Palo Verde Nuclear  
Generating Station

**Subject: Palo Verde Nuclear Generating Station (PVNGS)  
Docket Nos. STN 50-528, 50-529 and 50-530  
License Nos. NPF-41, NPF-51 and NPF-74  
20-Day Answer to NRC Order Establishing Interim  
Inspection Requirements for Reactor Pressure Vessel Heads,  
Dated February 11, 2003**

**Request for Relaxation of Order Requirements**

Figure 1

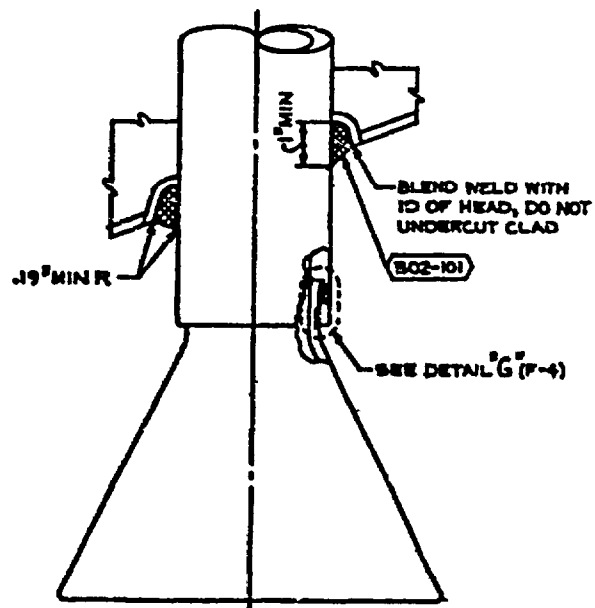
Due to the design of the funnel attachment to the CEDM nozzles (i.e., threaded connection with plug weld, see Figure 1), APS is unable to fully comply with the requirement to perform UT to the bottom of the nozzle.

PVNGS (Unit 2 Refueling outage 10 and Unit 1 Refueling Outage 10 in the spring and fall of 2002) has shown that scanning becomes impractical and ineffective from approximately 0.6 inches above the top of the nozzle's chamfer face to the bottom of the nozzle (see Figure 1, Detail "G"). Ultrasonic scans in this area do not yield useful data because of the geometry of the nozzle and funnel and the multiple signals reflected back by the threaded surfaces.

Ultrasonic testing of each RPV head penetration nozzle (i.e., nozzle base material) to approximately 0.6 inches above the top of the nozzle's chamfer face.
